| Technical Service Bulletin: TSB101081             | Released Date: 18-Feb-2011 |
| New Twin-Cylinder Air Compressor Support Brackets |                            |

This document introduces new air compressor support brackets for K19 and QSK19 engines that are equipped with the twin-cylinder air compressor, Part Number 3103409.

Figure 1, Old Design

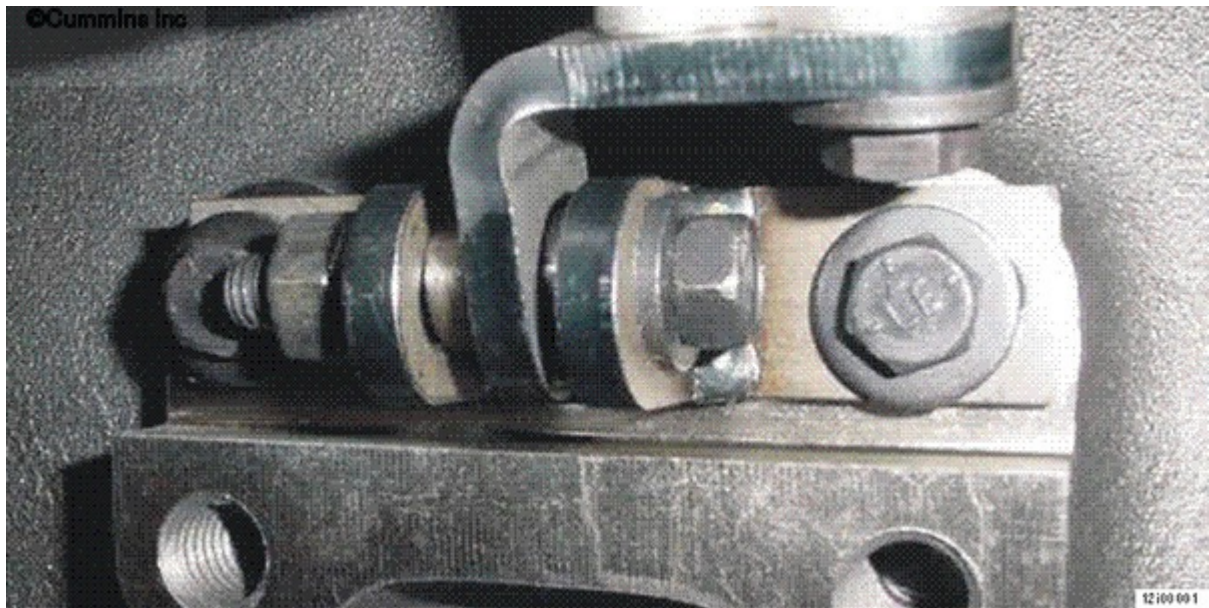
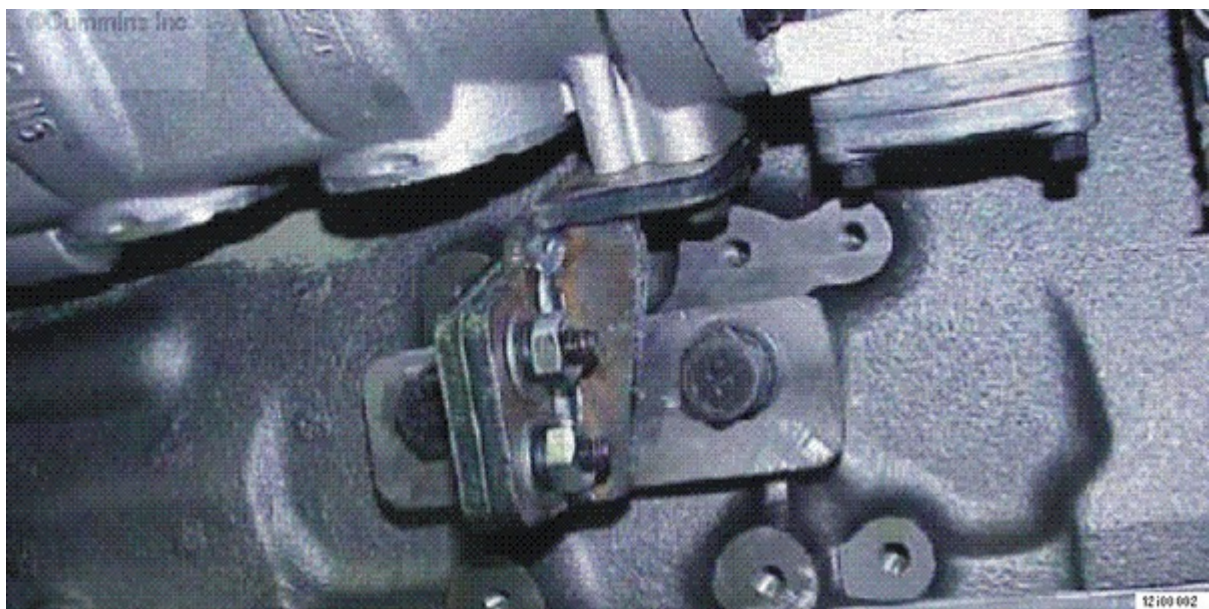
The new brackets, Part Numbers 2888623 and 2888626, obsolete and supersede the previous versions, Part Numbers 4081295 and 4081296. These brackets are being introduced as a product improvement. The new design is a two-piece, rigid-mounted bracket design. This design eliminates the wear that was seen on the previous brackets caused by movement between the two bracket pieces. The difference between the two bracket designs are shown in Figure 1, Old Design, and Figure 2, New Design.

Figure 2, New Design

Figure 3, Alternate Fuel Filter Mounting Location

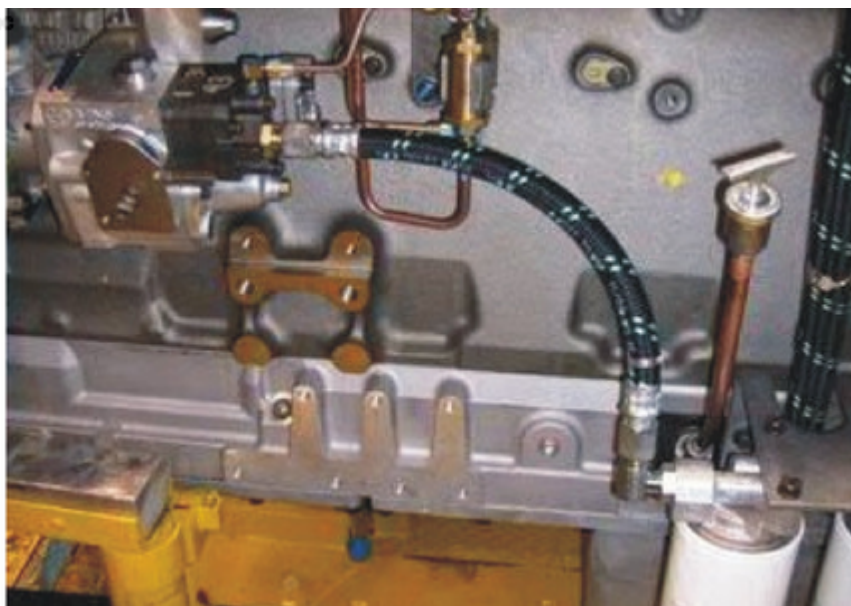
The new bracket design utilizes the same mounting holes as the fuel filter options that were mounted directly below the old air compressor support bracket. These options are listed in Table 3. In order to install the new air compressor support bracket design, these fuel filter options **must** be moved. The fuel filter option may be remote mounted or moved to the hand hole cover, as shown in Figure 3. It may be necessary to rotate the fuel filter housing 180 degrees to allow proper routing of the fuel pump inlet hose. Table 4 lists fuel line part numbers and lengths that can be ordered for the new fuel filter mounting locations.
